主旨: [Departmental Comment] Planning Application No. A/YL-KTS/1077

Section 16 Planning Application No. A/YL-KTS/1077

We reply to DSD's comments.

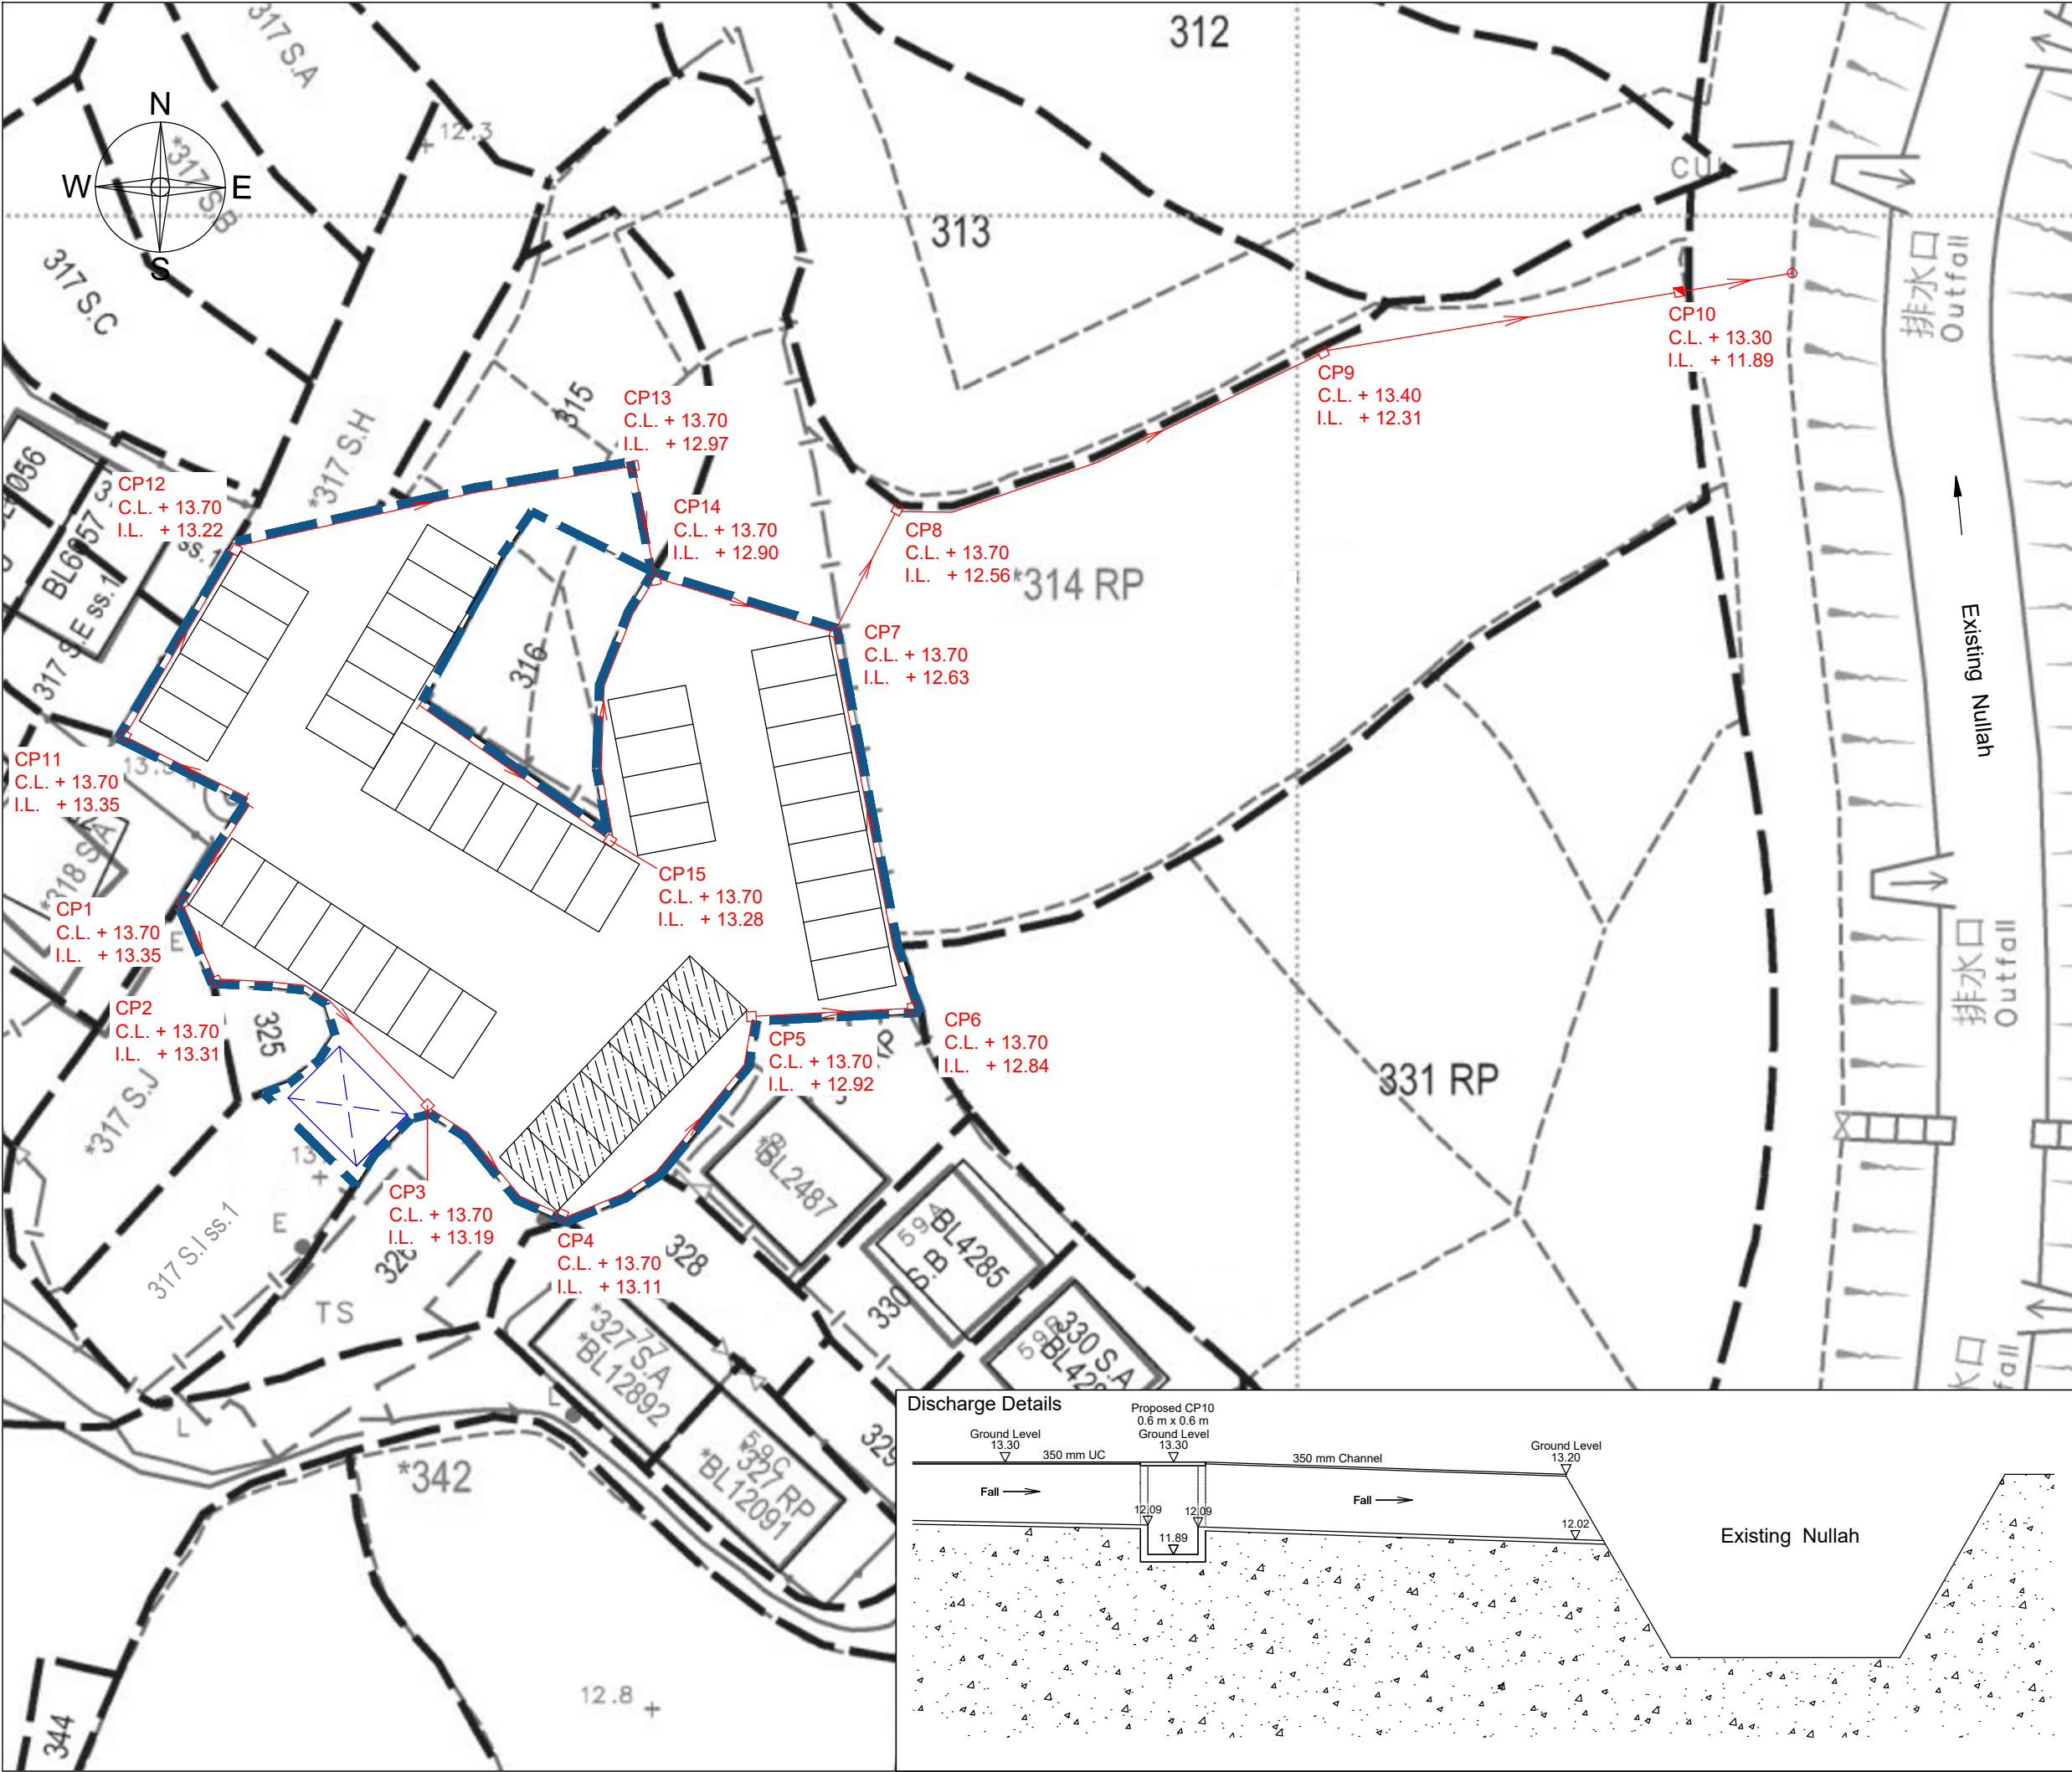
- c. We ensure that the land filling works will not affect the overland flow from the adjacent lands.
- d. Please refer to the Drainage Plan.
- e. Please refer to the hydraulic calculations.

Catchpit and U-Channel Details

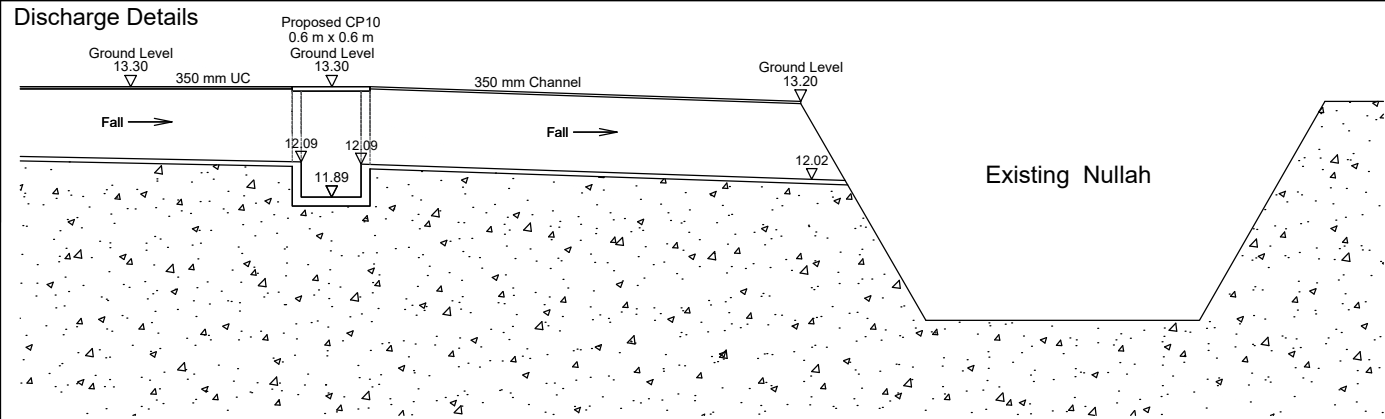
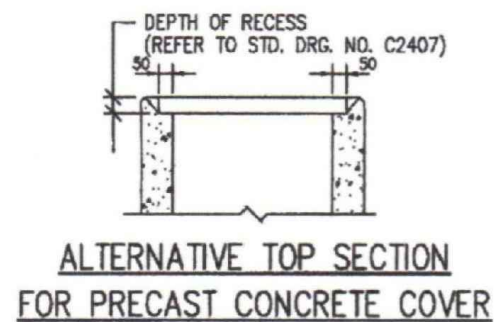
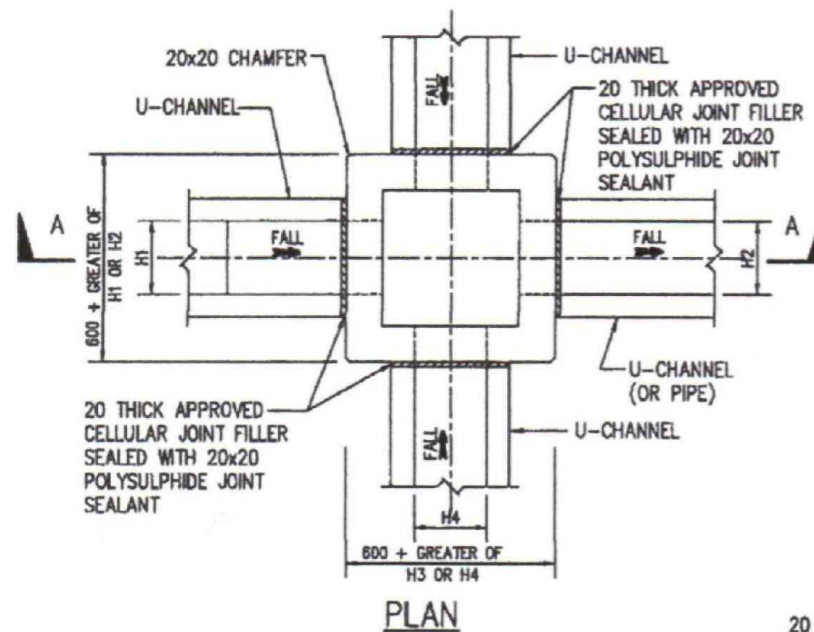
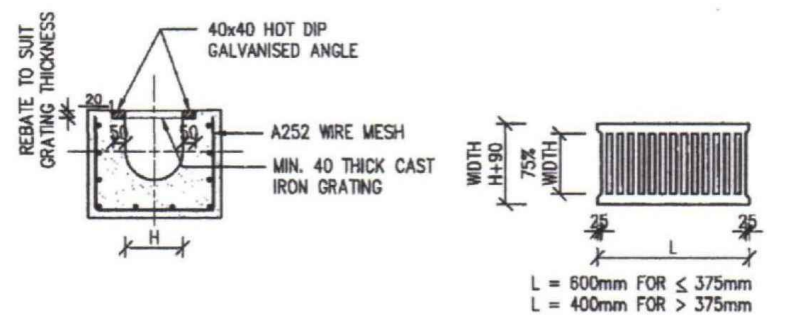
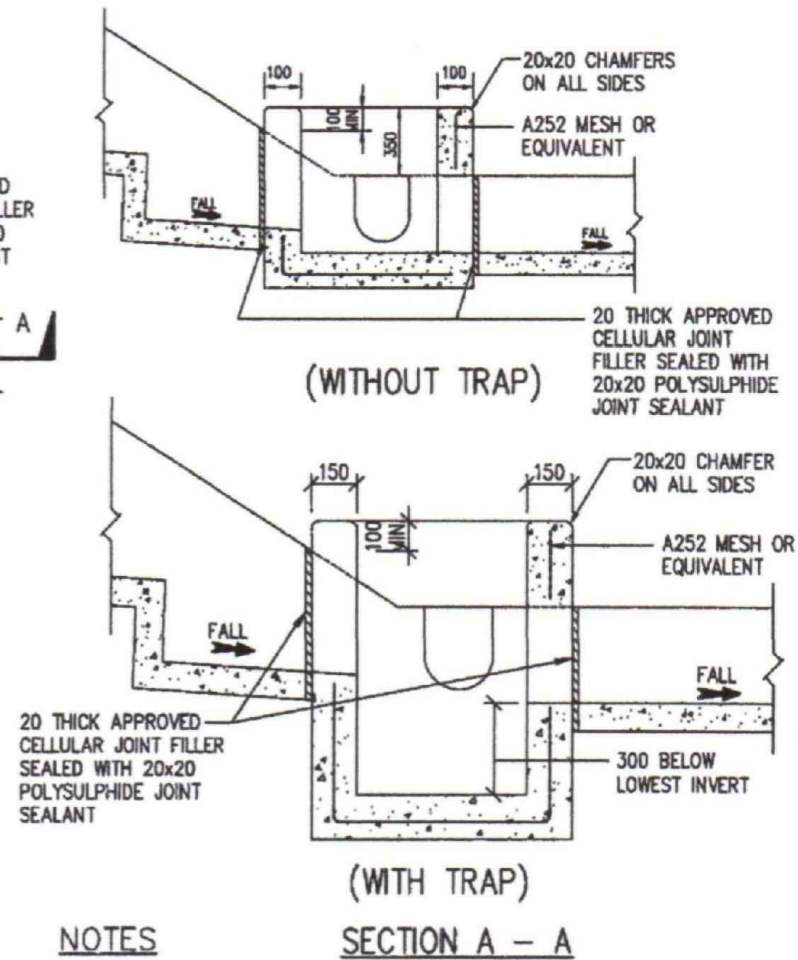
- i. Please refer to the Cross Sections Plan.
- j. Please refer to the Catchpit and U-Channel Details.
- k. We ensure that the development will not obstruct overland flow nor adversely affect existing natural streams, village drains, ditches and the adjacent areas, etc.
